DOCUMENTATION OF ADVERSE EFFECT

MEMORANDUM OF AGREEMENT

***Rehabilitation of State Bridge No. 698, Van Buren Street Bridge
Located in Brandywine Park, Wilmington, New Castle County, Delaware***

***State Contract Number 92-074-04
Federal Aid Number EBH-698(1)***

FIGURE 2

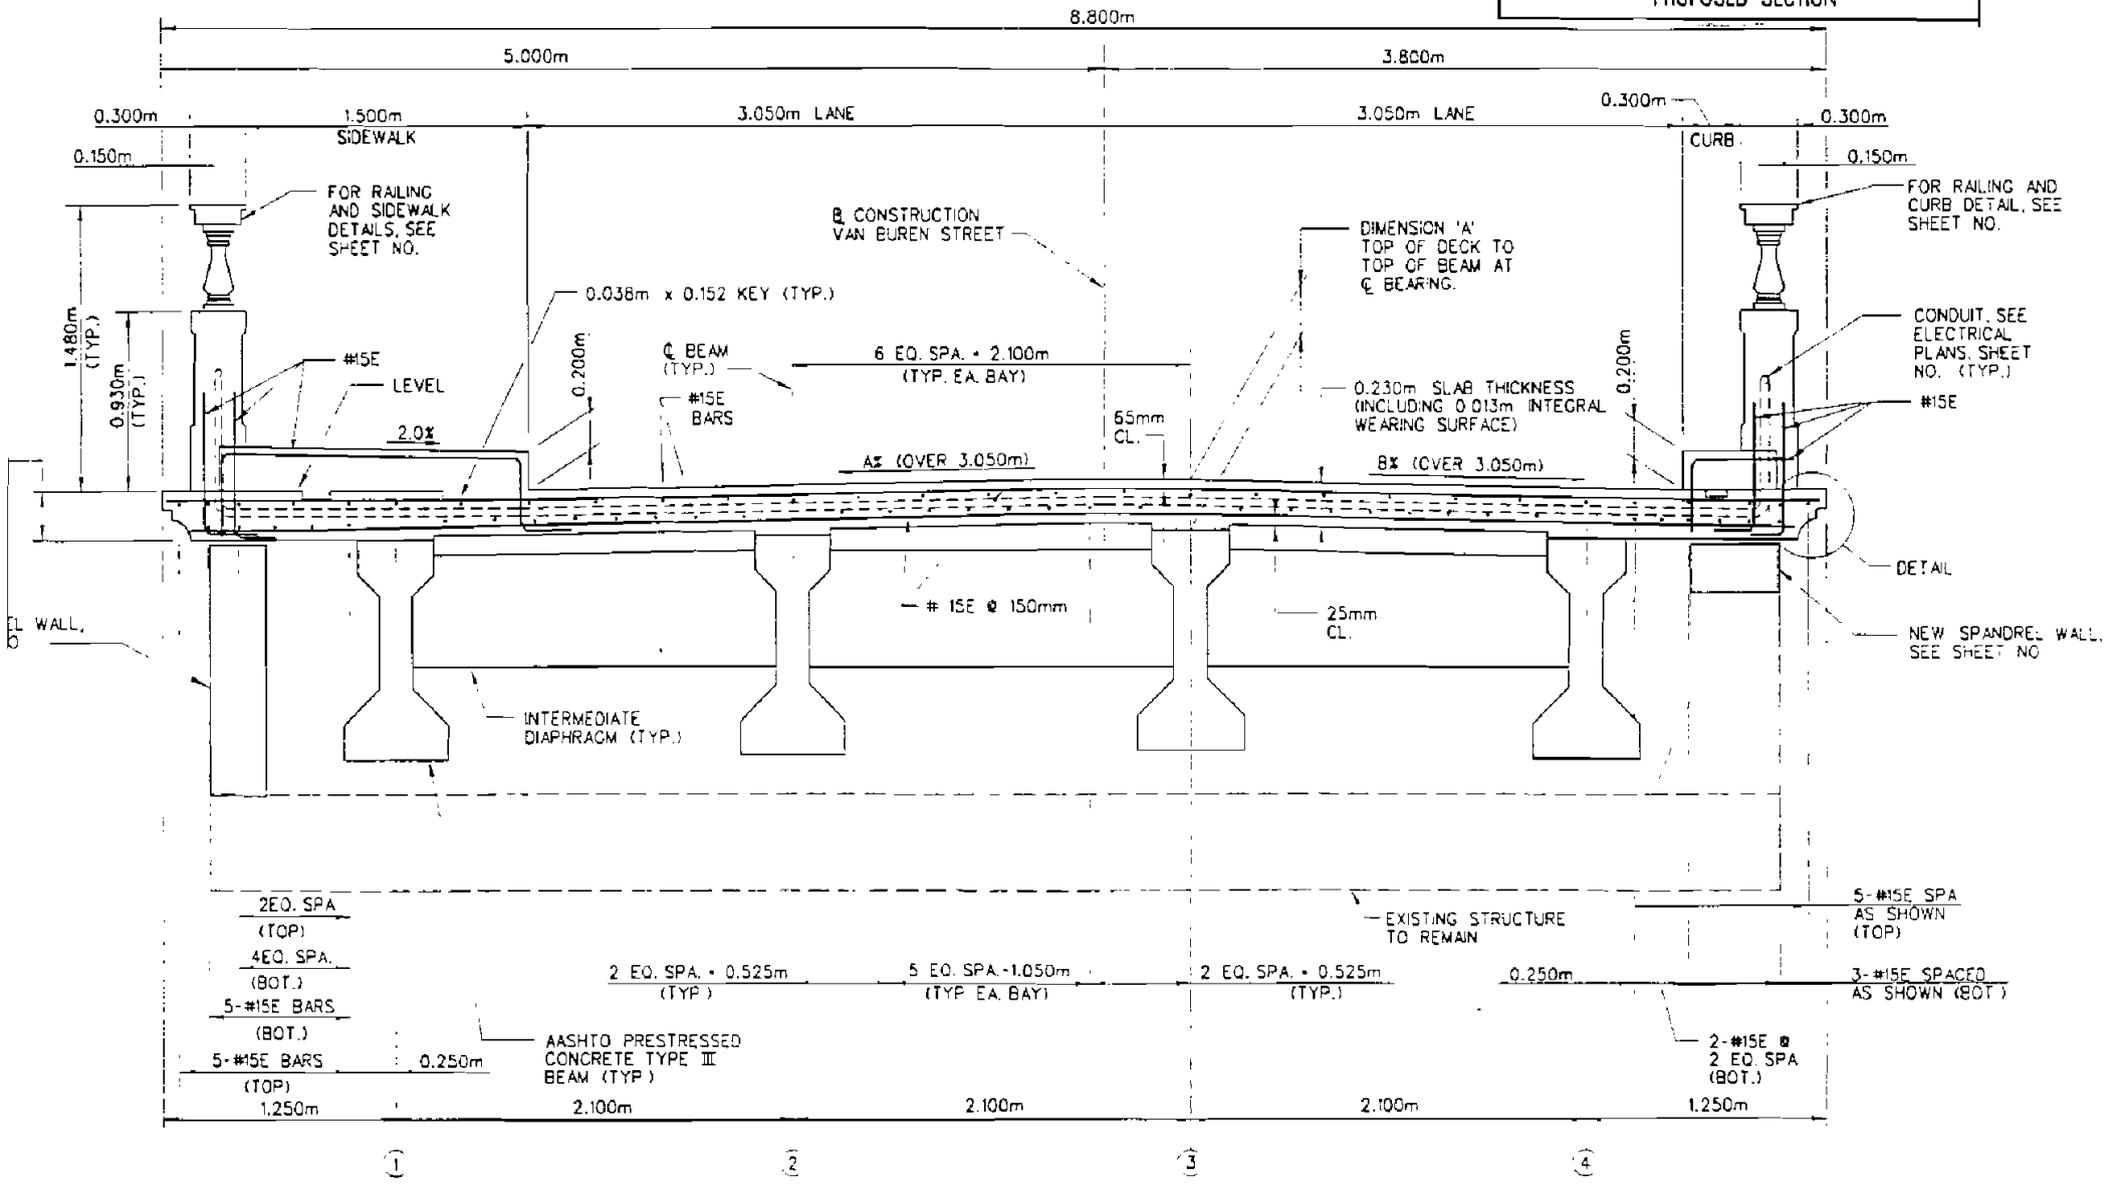
2. **ca. p. 4:** add a diagram indicating the existing profile of the bridge, for comparison with proposed shown in Figure 2. The diagram you used for the public workshops would be sufficient.
